DEPARTMENT OF TRANSPORTATION

File: 07-LA-405 28.8/39.0
 I-405 Sepulveda Pass HOV
 Widening (I-10 to US-101)
 EA 120300

This letter serves to notice of portions of the Draft EIR/EIS that have been modified for clarification purposes. In addition, a design variation of Alternative 3 which would make design modifications to the freeway and Church Lane to avoid full property acquisitions in the community of Brentwood Glen has been developed. Changes to the Draft EIR/EIS have been underlined for your reference. The following table summarizes the changes that are enclosed and have been incorporated into the Draft EIR/EIS:

Figure S-2: Project Location Map

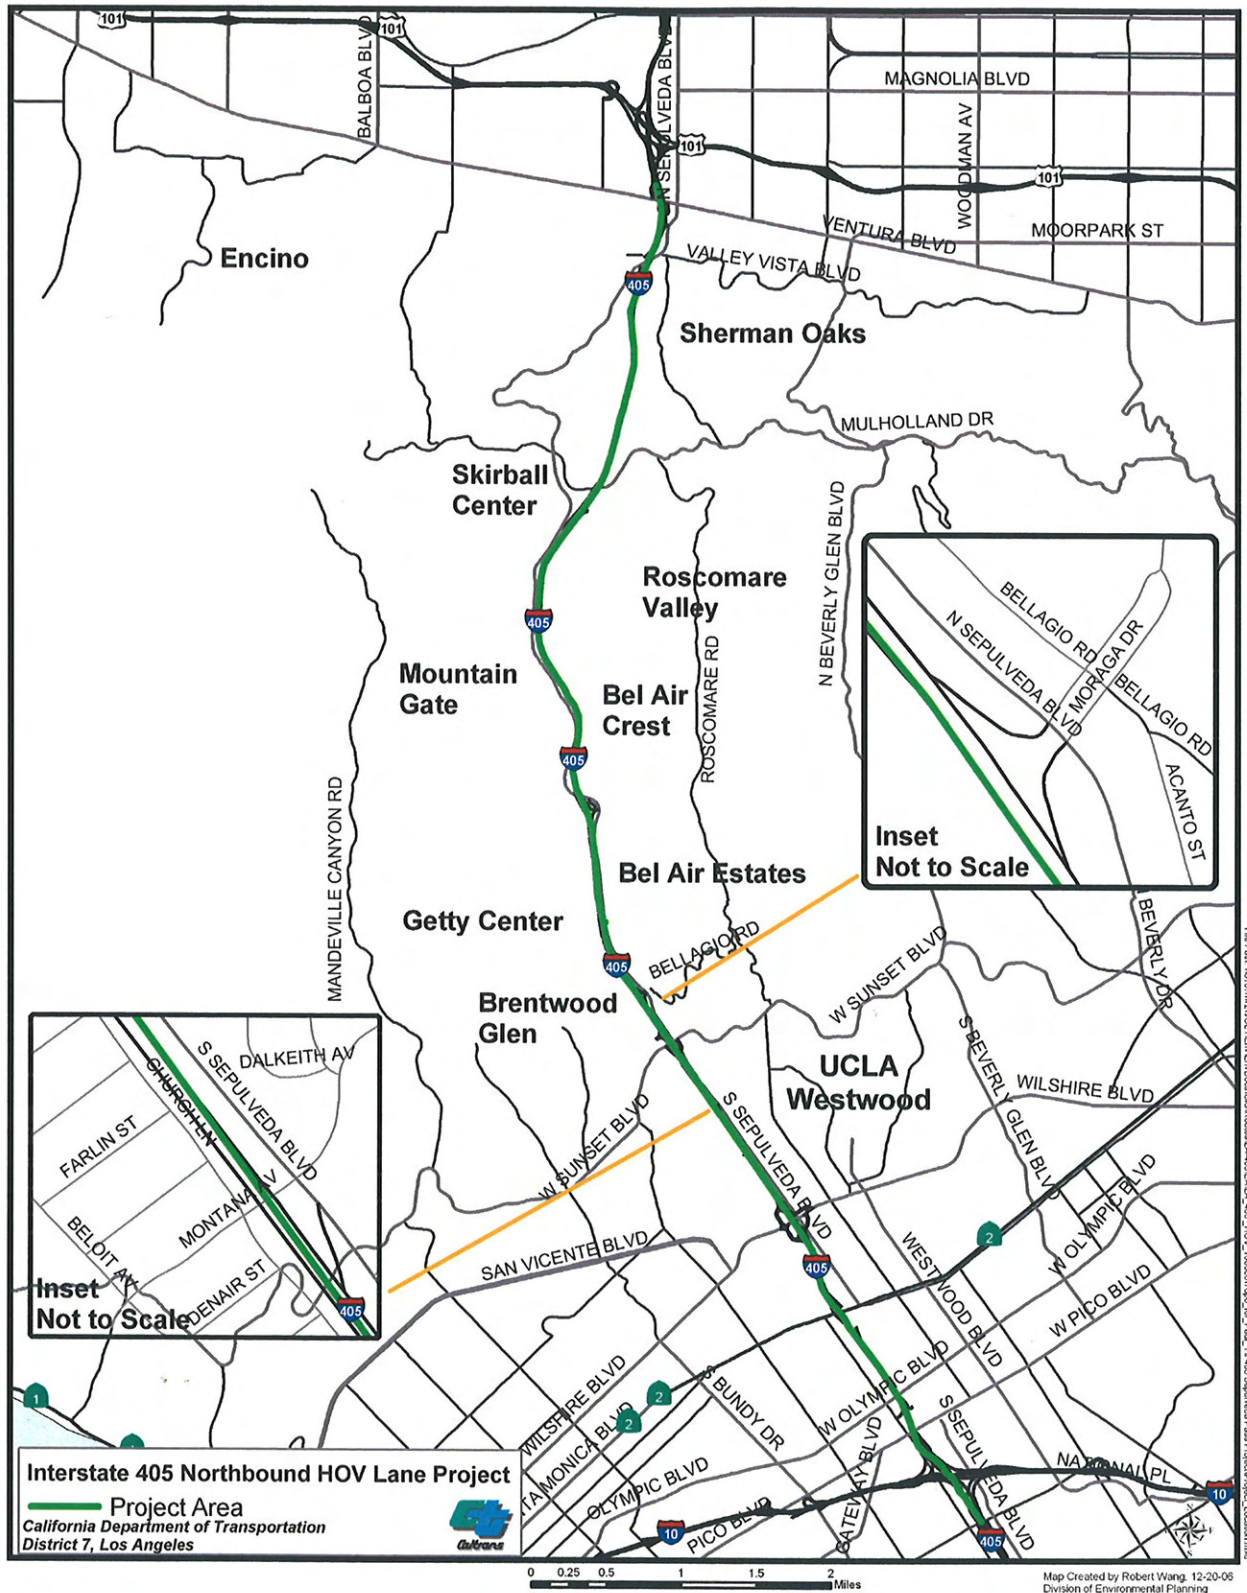
Original Page #	Clarification
3	Additional communities identified on the Project Location Map
8	Conceptual Cross-Section figure revised
9	Addition of one mixed-flow lane from Skirball Center Dr. to Waterford St. and Alternative 3 Modified and Park and Ride Facilities
14 - 15	Summary of Major Potential Impacts Table (Housing Displacement, Community Service Disruption, Ramp Closures, Utilities and Emergency Services, Traffic Circulation, Parking, Visual Quality and Air Quality)
23	The project <u>would add</u> a mixed-flow lane on I-405 in the southbound direction from Skirball Center Dr. to Waterford St.
29	Conceptual Cross-Section figure revised
30	Addition of one mixed-flow lane from Skirball Center Dr. to Waterford St. and Alternative 3 Modified
37	Updated List of Technical Studies
75	Alternative 3 Modified – Reduced community impacts in Brentwood Glen
120-123	Traffic Impacts at Sherman Oaks Ave. with new on-ramp
